Rule #61 — Wall brace W chamfer — 28° threshold

Example: HG260001 | plan GF-LBW-70.075 | frame PK4-L27 | stick W2

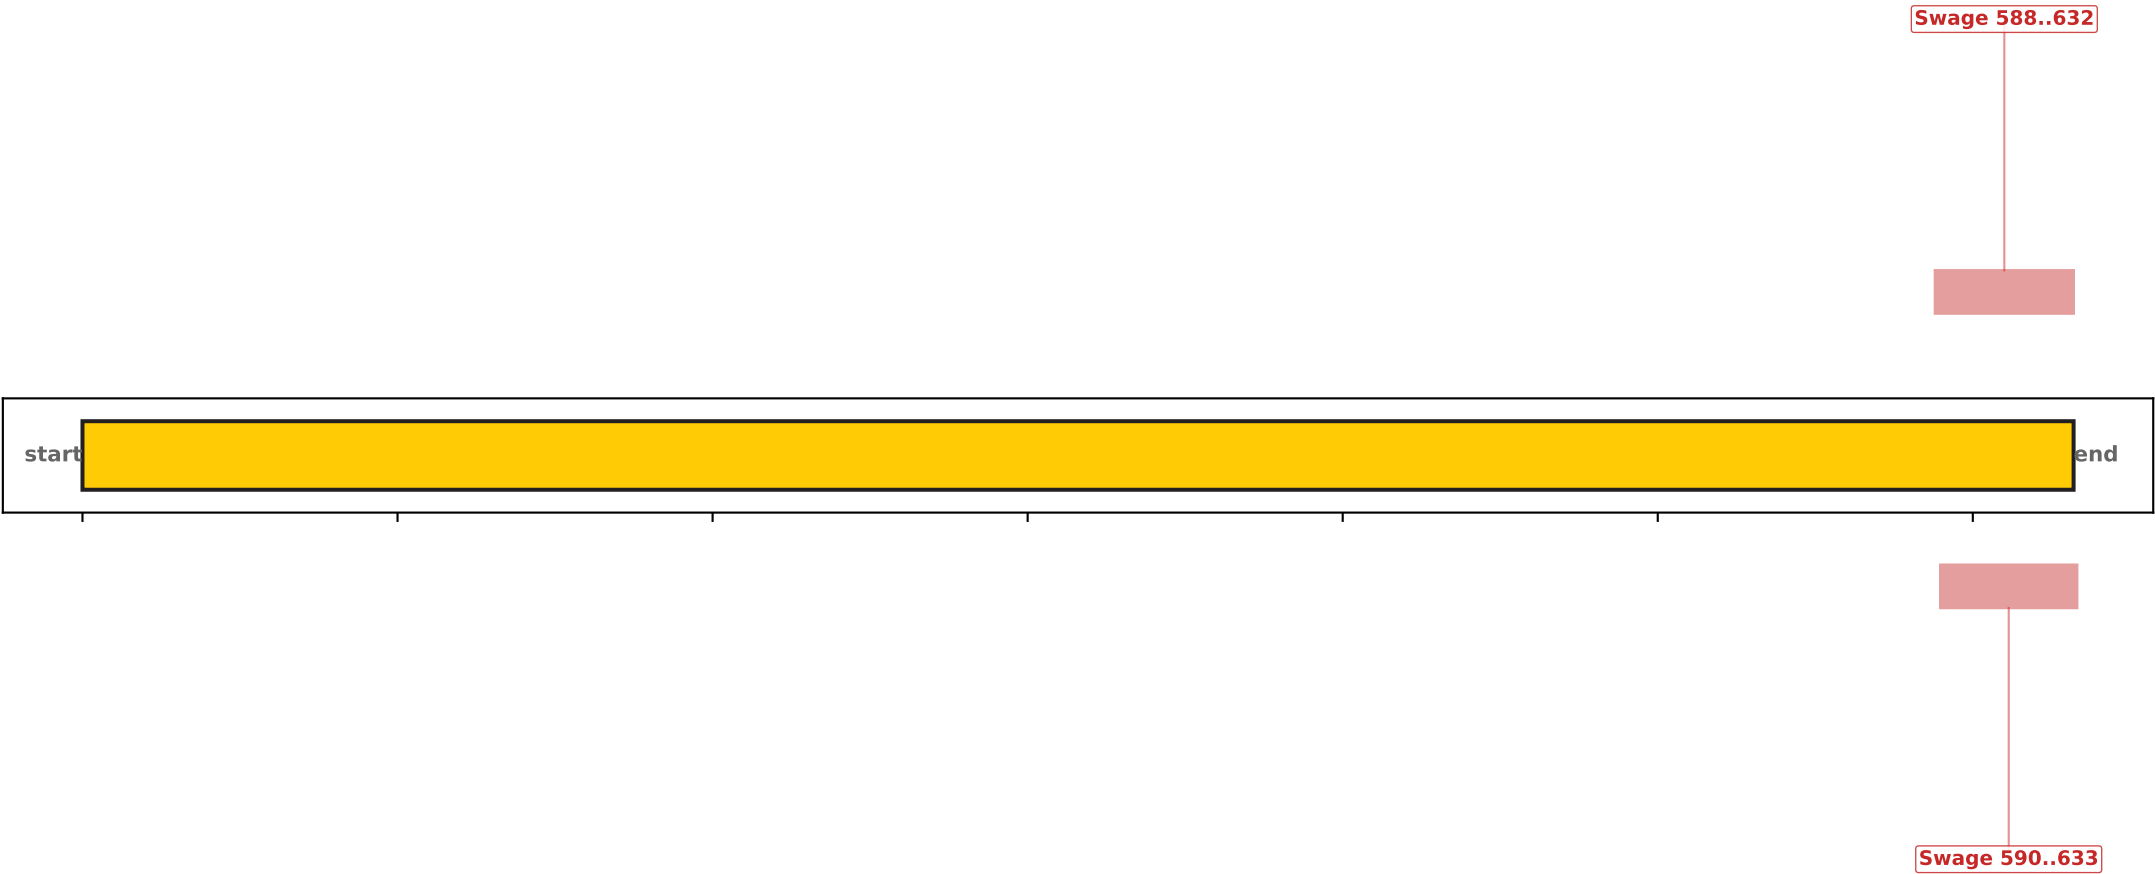
Wall brace W chamfer threshold ~28° from vertical. Is that the actual rule?

(extra)
Detailer
doesn't
have these

(missing)
codec
should have
emitted these

- Matched ops: 3
- Extras (codec emits, Detailer doesn't): 1
- Missing (Detailer has, codec doesn't): 1
